Proposed Solar Farm & Battery Store Little Llwyn Onn, Cefn Road, Wrexham (P/2022/0541)

Ecological Addendum

Fig 4. GCN Mitigation Guidelines (2004)

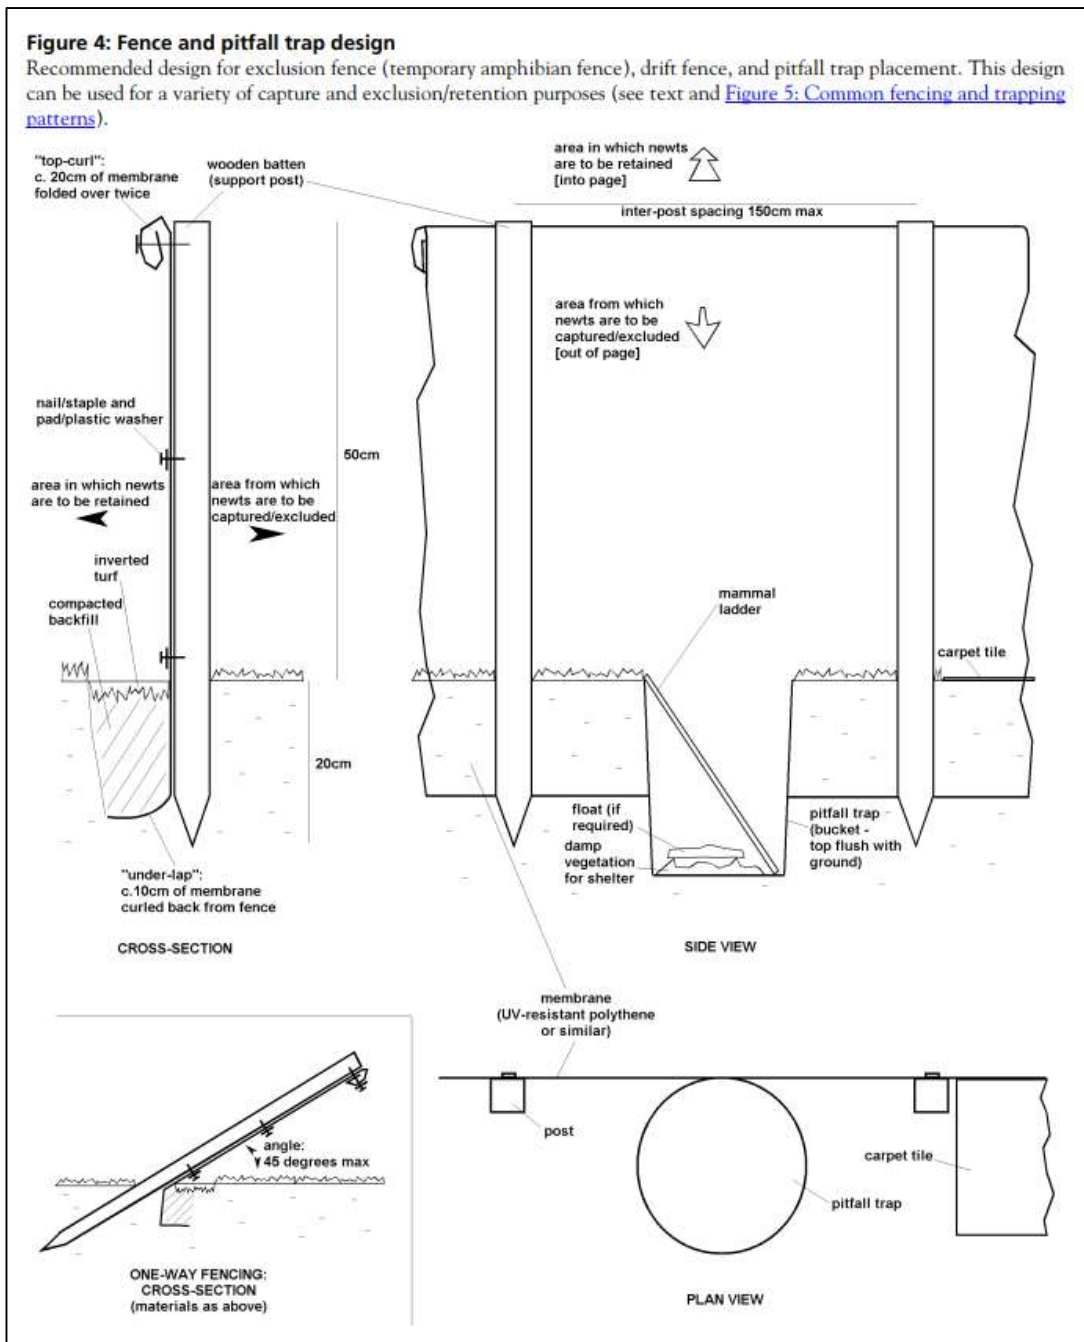
NRW have requested further information relating to the fencing design, specifications and locations, considerations of access, monitoring and maintenance, as well as fence removal and proposed timescales for the mitigation strategy. Additional issues raised by NRW are covered in the other sections of this document.

Fencing design will meet the industry standards detailed in the GCN Mitigation Guidelines (as shown below). All fencing will comprise upright temporary amphibian fencing (TAF) with pitfall traps every 10m and carpet tiles or felt at alternate 10m intervals. The fencing will extend around the whole of the development footprint north of Cefn Road, as shown on Figure 2 of the GCN Mitigation Strategy document already submitted. Access points for construction vehicles will be provided by way of openings in the fence-line. These openings will be up to

10m wide and the TAF will be turned back to prevent GCN from re-entering the site after the completion of trapping.
